**CAPITOL ZONING DISTRICT COMMISSION
STAFF REPORT 2023-018
9/21/23
JCL**

Location: 17th & Scott
Applicant: Cope Gracy for Riverwalk Properties, LLC.
Permit Types: Certificate of Appropriateness

Project Description: The applicant is seeking a Certificate of Appropriates to demolish an existing car wash and construct 12 new, single bedroom townhomes. The proposal is part of a larger development split by the CZDC boundary between Scott and Cumberland Streets, where 12 additional units are proposed. Those units within the CZDC boundary are labeled as Phase 2 on the site plans.

① EAST ELEVATION COLOR
1/4" = 1'-0"

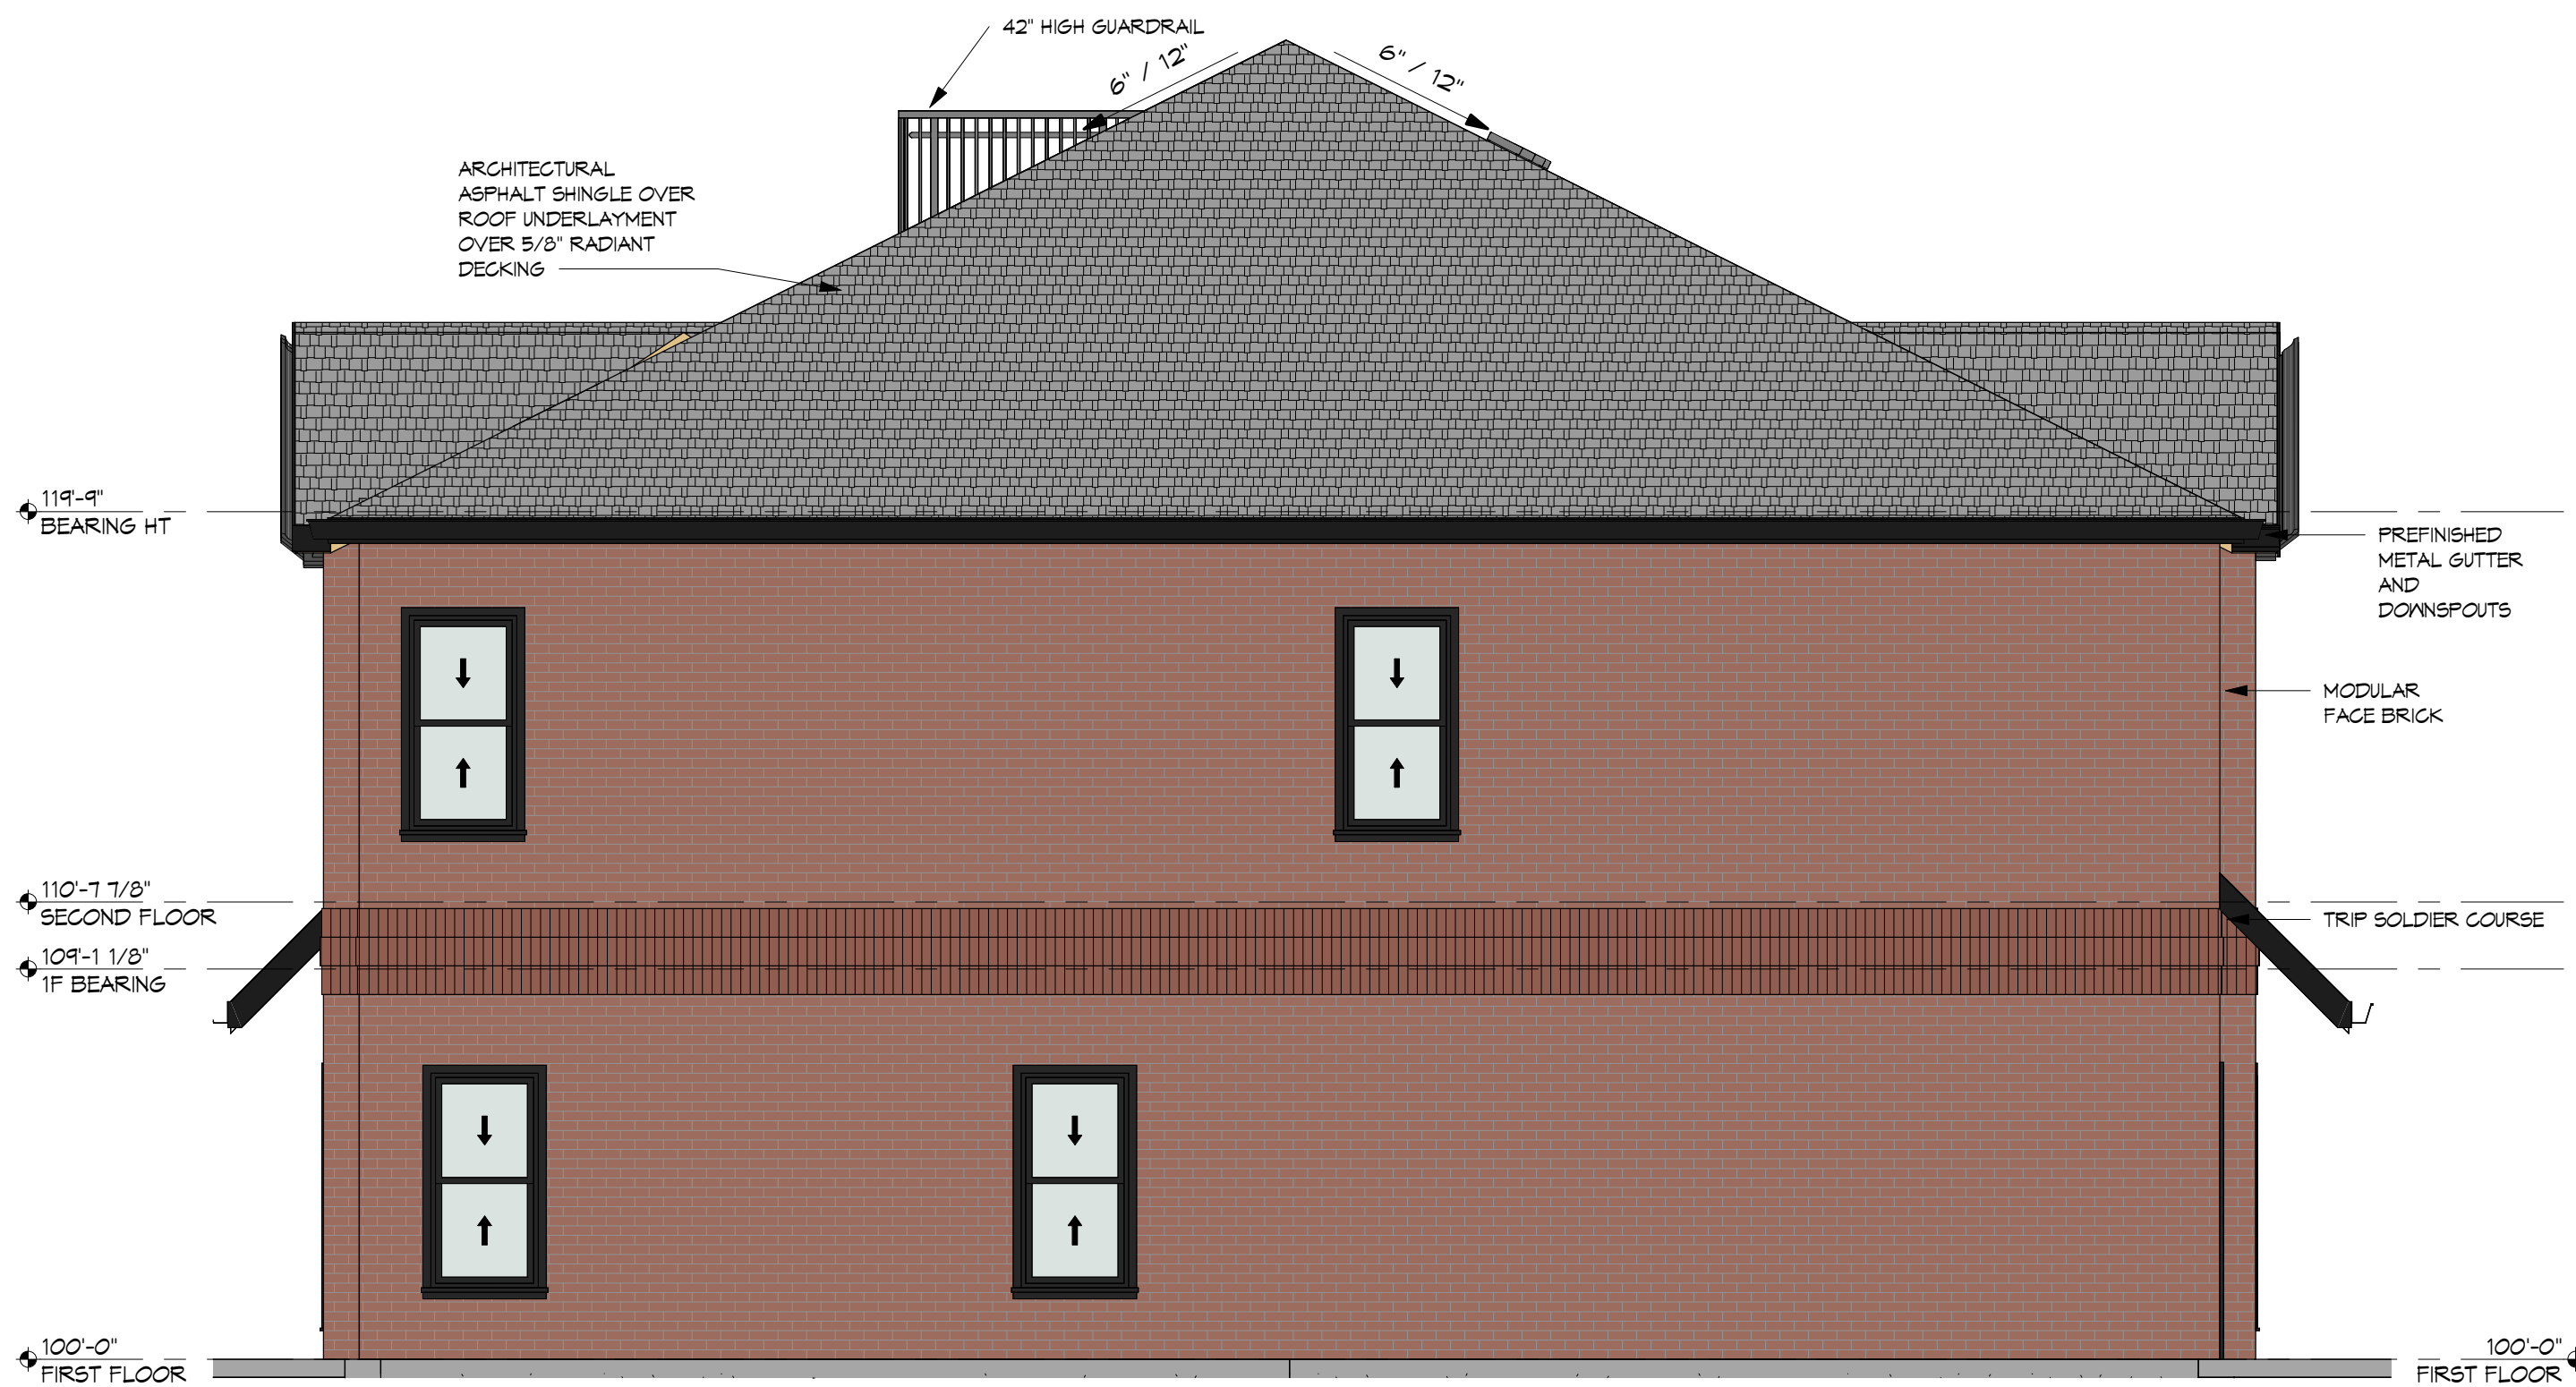
The expression of standard modules is maintained through the townhomes projecting gables, as well as differentiation in brick color. The soldier course also helps to break up the façade and provides other visual interest. Rooftop mechanicals will be screened from 17th street while both east/west facades are not void of any windows.

- First floor windows shall be divided with surface muntins.
- The peaks of the gables shall contain a vent or brick detail.
- To comply with CZ/ LR landscape requirements.

- 1) That all state and city codes be followed at all times.
- 2) That the property be maintained in a neat and safe condition at all times.
- 3) Phase two parking to include 1 reserved space for the disabled.
- 4) First floor windows shall be divided with surface muntins.
- 5) The peaks of the gables shall contain a vent or brick detail.
- 6) To comply with CZ/ LR landscape requirements.
